Hornsea Project Three  
Offshore Wind Farm

### Appendix 34 to Deadline 4 submission - Noise Clarifications (Herring Spawning)

Date: 15<sup>th</sup> January 2019

Figure 1.1: Unweighted cumulative Sound Exposure Levels (SEL<sub>cum</sub>) for concurrent piling of monopiles at 5,000 kJ hammer energy (assumes a stationary fish).

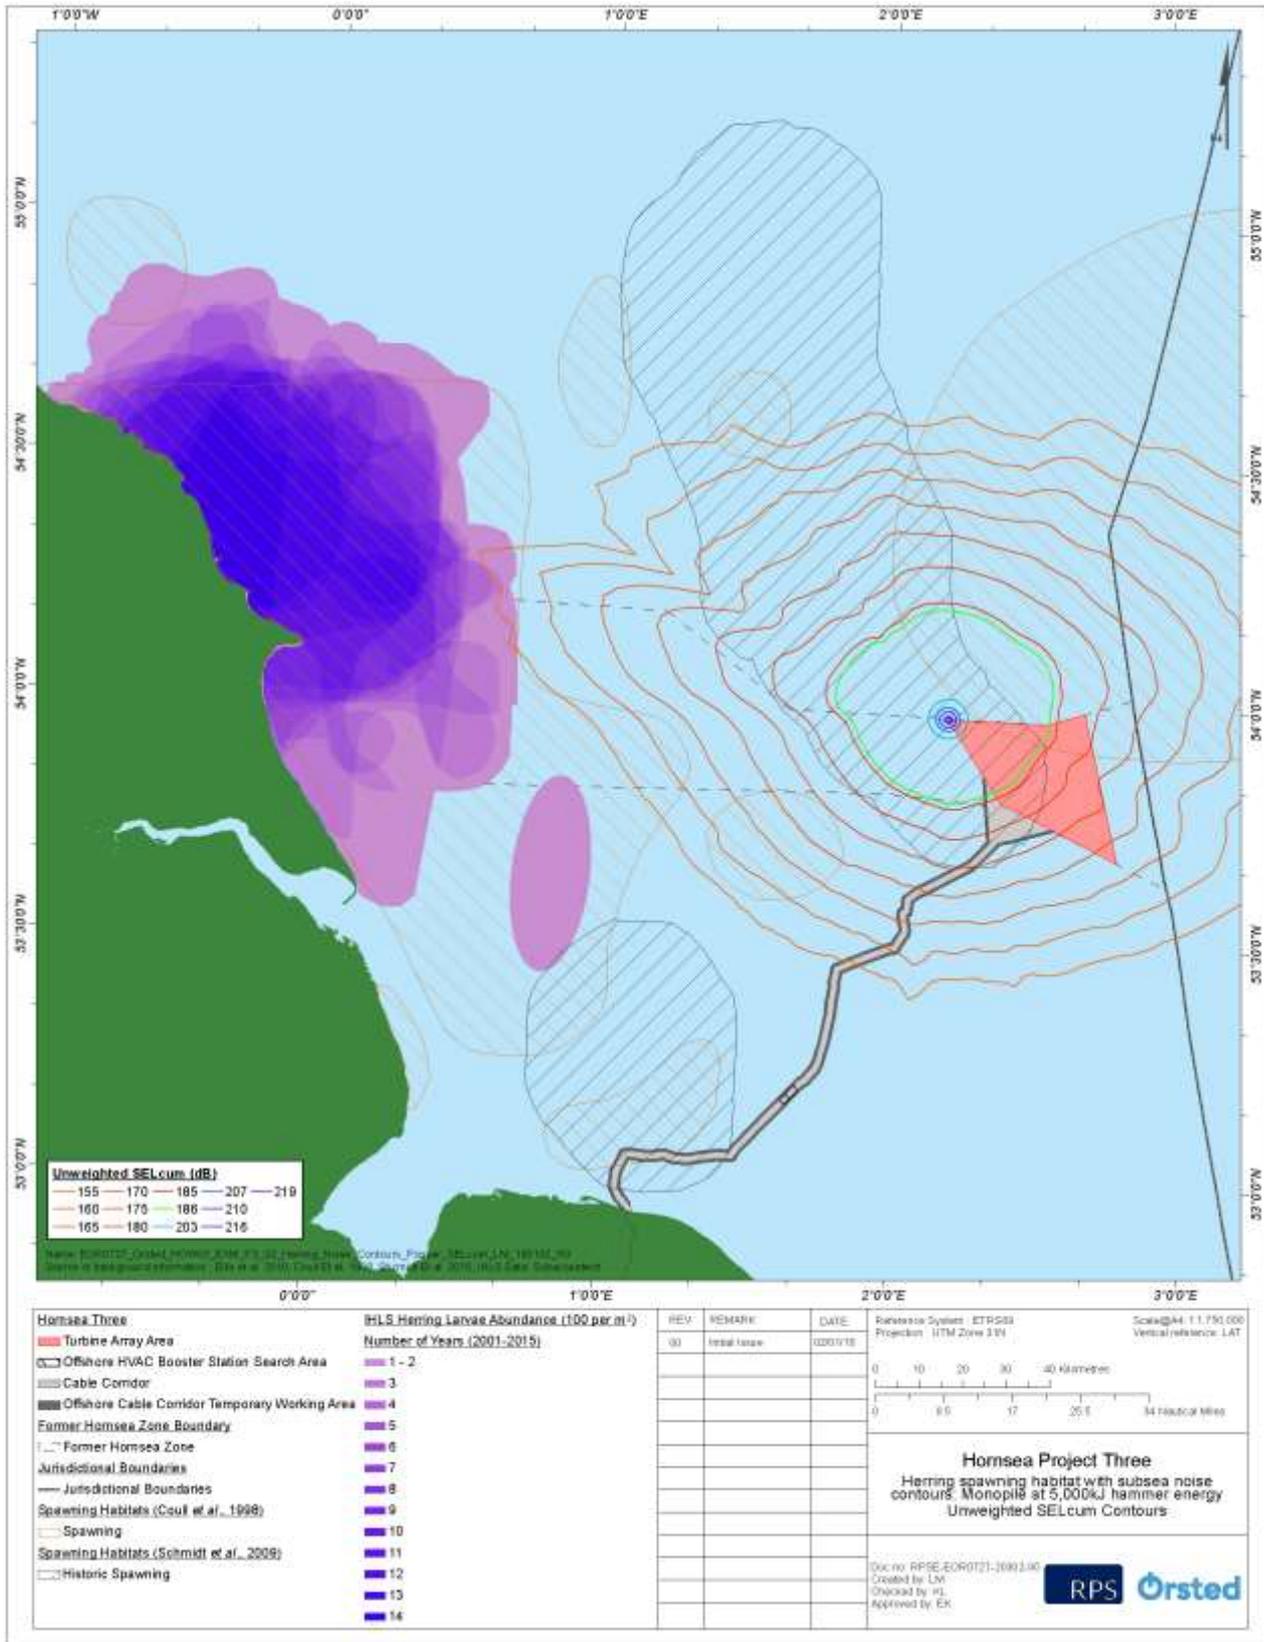
- 1.1 In their Deadline 3 submissions, the Marine Management Organisation (MMO) requested a number of clarifications with respect to the potential for effects on herring spawning at Flamborough Head (REP3-095). Specifically, the MMO requested the following:

- The modelled received levels for SEL<sub>cum</sub> based on concurrent piling, as has been done for the peak SPL (showing the contours and spawning habitats);

- The hammer energy profiles for the SEL<sub>cum</sub> scenarios (including the number of piles installed in 24 hours, number of strikes, source level); and

- 1.2 Figure 1.1 shows the updated modelling of received levels for cumulative Sound Exposure Levels (SEL<sub>cum</sub>) assuming a stationary fish receptor. This modelling assumes two monopiles being installed simultaneously, using the maximum design scenario for hammer energy (i.e. 5,000 kJ) in the north-west corner of the Hornsea Three array area (i.e. the closest point to the Flamborough Head herring spawning ground).

- 1.3 Figure 1.1 shows the impact thresholds for injury and temporary threshold shift (TTS) from Popper et al. (2014) with the TTS threshold (i.e. 186 dB SEL<sub>cum</sub>) over 60 km from the eastern edge of the mapped herring spawning ground off Flamborough Head, confirming that there is no risk of injury to herring at the Flamborough Head spawning ground. Figure 1.1 also shows that the received noise levels in the vicinity of the Flamborough Head herring spawning ground are very low, i.e. approximately 155 dB SEL<sub>cum</sub>, which is of the same order as if a receptor was exposed to ambient coastal noise for 24 hours. The Applicant would like to clarify that the received level previously provided to the MMO (clarification provided to MMO on 3<sup>rd</sup> December 2018; see REP3-095) was based on a simple calculation based on the absolute worst case, rather than modelling. The more detailed modelling presented in Figure 1.1, shows that this was over-conservative and the predicted SEL<sub>cum</sub> noise levels are even lower than the estimate provided in the previous clarification.

- 1.4 All modelling was undertaken using the piling ramp-up as defined in the Volume 4, Annex 3.1: Subsea Noise Technical Report (APP-085), reproduced in Table 1.1 below. This assumes up to two monopiles installed in a 24 hour period.

Figure 1.2: Unweighted single strike Sound Exposure Levels (SEL<sub>ss</sub>) for concurrent piling of monopiles at 5,000 kJ hammer energy.

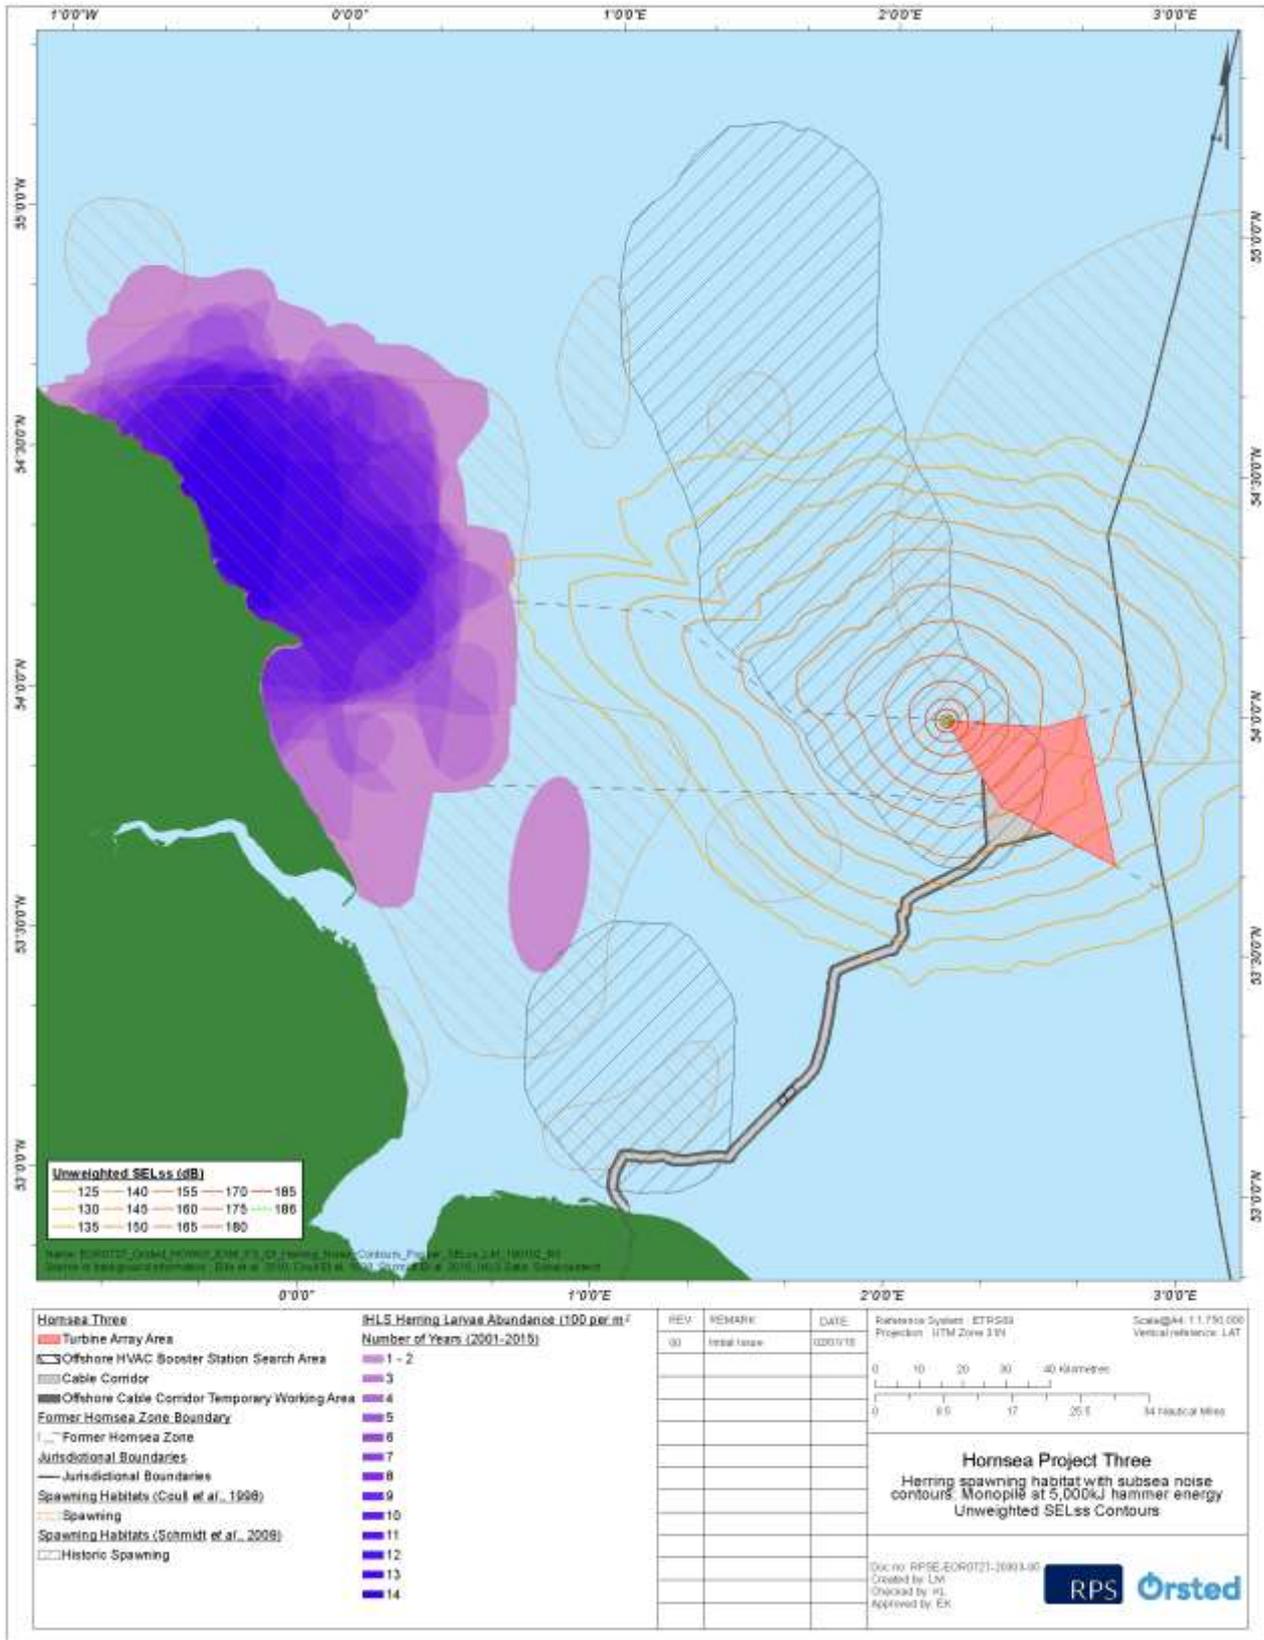
- The unweighted single strike SEL (SEL<sub>ss</sub>) received levels based on concurrent piling and a 5,000 kJ hammer energy (showing the contours and spawning habitats).

- 1.5 Figure 1.2 shows the results of this modelling of the single strike SEL ( $SEL_{ss}$ ) noise levels based on a 5,000 kJ energy and concurrent piling, as requested by the MMO. The results of these modelling also demonstrate that noise levels will be extremely low, even in a maximum design scenario for hammer energy and location of piling, with noise levels  $<125$  dB  $SEL_{ss}$  considered to be approaching the order of background noise.
